# COMMITTEE OF ADJUSTMENT

**MINOR VARIANCE REPORT**

**APPLICATION: CAV A/085/2024**

### **CAV A/085/2024 – 216 Forestwood Dr (East District) (OP Designation: Low Density Residential – Special Policy)**

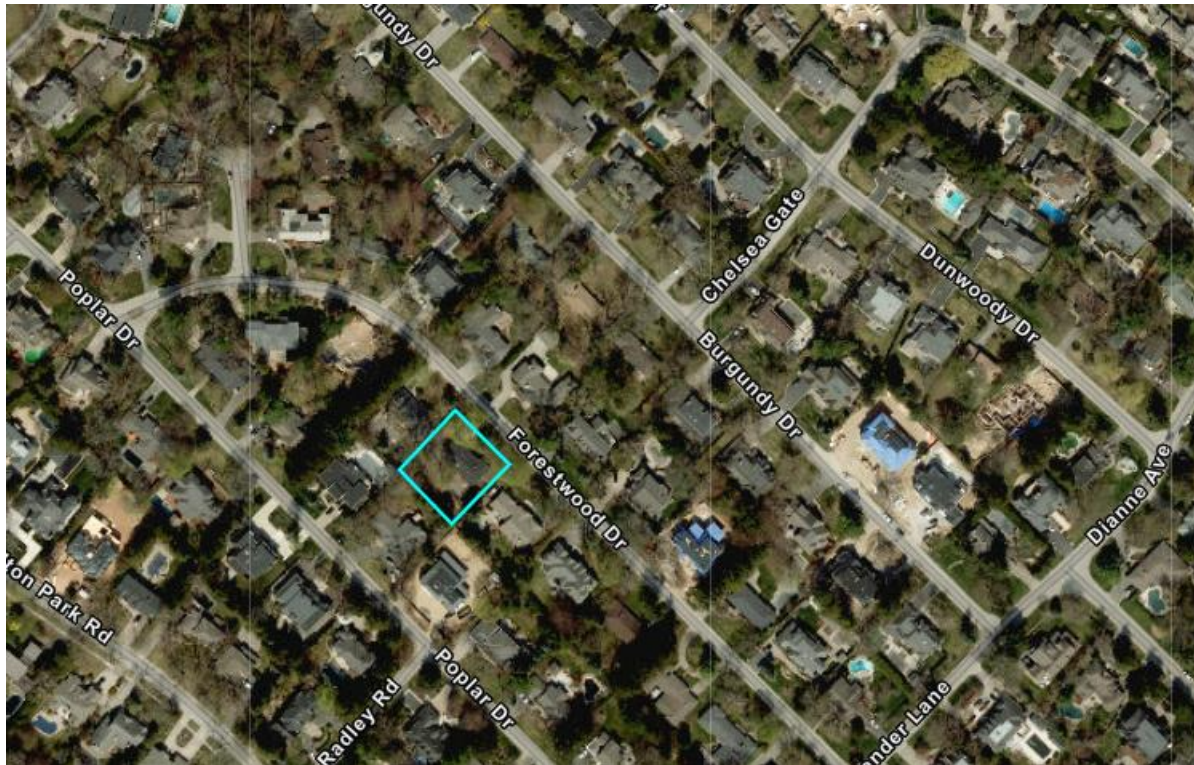
The subject property is located on the southwest side of Forestwood Drive, as seen in the aerial photo below. The neighbourhood consists of original one and one-and-a-half-storey dwellings, along with many newer two-storey dwellings.
